Summary and Response to Stakeholder Comments
ENERGY STAR Program Test Method for Determining Displays Energy Use Version 6.0 Draft 4

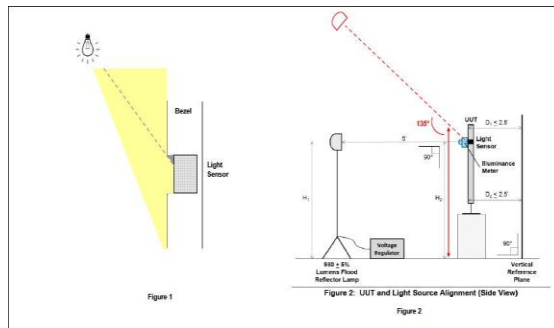
In general, the light sensor cannot receive the total amount of light in the room, because it is installed in the bezel that comes to block part of light as shown in Figure1. The ABC function is adjusted optimally under this real environment, and if the light source is aimed directly toward the light sensor, the brightness of the product would be raised too high.

Instead of shining light directly into the sensor, it is illuminated obliquely downward as shown by red-colored description in Figure 2, considering real environment.

If light shines directly into the sensor, the level of the ambient light sensor should be re-evaluated considering the room lighting as real environment.

For example, 5lux, 50lux, 150lux and 250lux rather than 10lux, 100lux, 300lux and 500lux.

DOE believes that the alignment and the positioning of the light sensor in the bezel varies for different products. In addition, in the investigative testing performed, DOE observed most repeatable and consistent results with the center of the light source aligned at a horizontal angle of 0° and a vertical angle of 0° with respect to the center of the light sensor. DOE also observed that measuring at a vertical angle greater than 0° will not completely stress the ABC sensor.

DOE does not agree with re-evaluating room illuminance levels for testing, as both DOE and EPA believe that the lighting levels of 10 lux, 100 lux, 300 lux, and 500 lux provide power consumption values for very low to very high room illuminance values. As such, DOE has retained these lux levels in the Final Draft of the Test Method (Rev June-2012).
